28/02/2020

Pre-Development Consultation Review  
10 Willandra Rd Beacon Hill, NSW 2100.

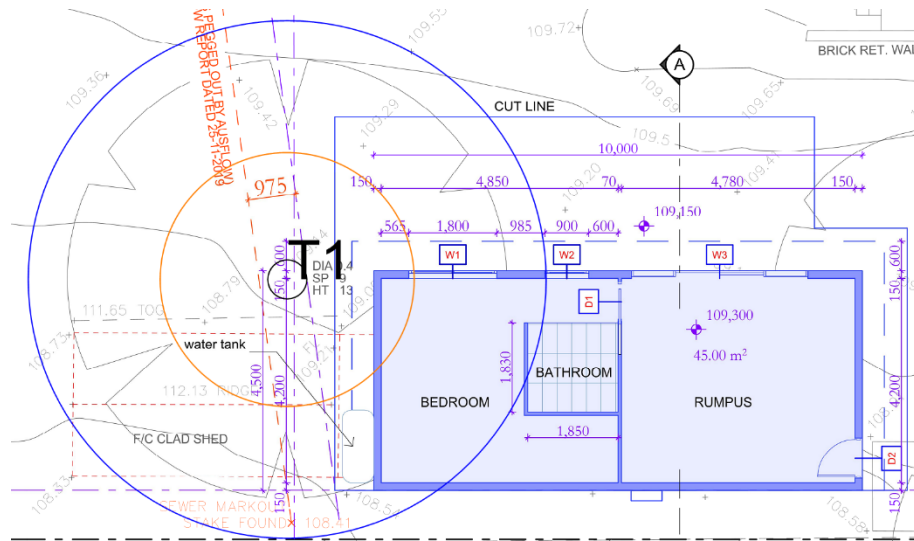
The proposed development consists of an outbuilding (studio) within the rear yard. An excerpt from the Ground floor plan below shows the TPZ (blue) and SRZ (orange) of T1 overlayed.

Tree number	Proposed encroachment within TPZ.	Conclusion
T1	T1 is will have a major encroachment to the TPZ and an encroachment to the SRZ from the proposed development. The proposed cut is likely to require the removal of structural roots that could result in windthrow or whole tree failure.	T1 will be required to be removed to facilitate the proposed development in its current design. T1 has a Low retention value and should not be a constraint to development. It is recommended that an advanced replacement tree (75L pot size or larger) indigenous to the Northern Beaches is included in the proposed DA submission.
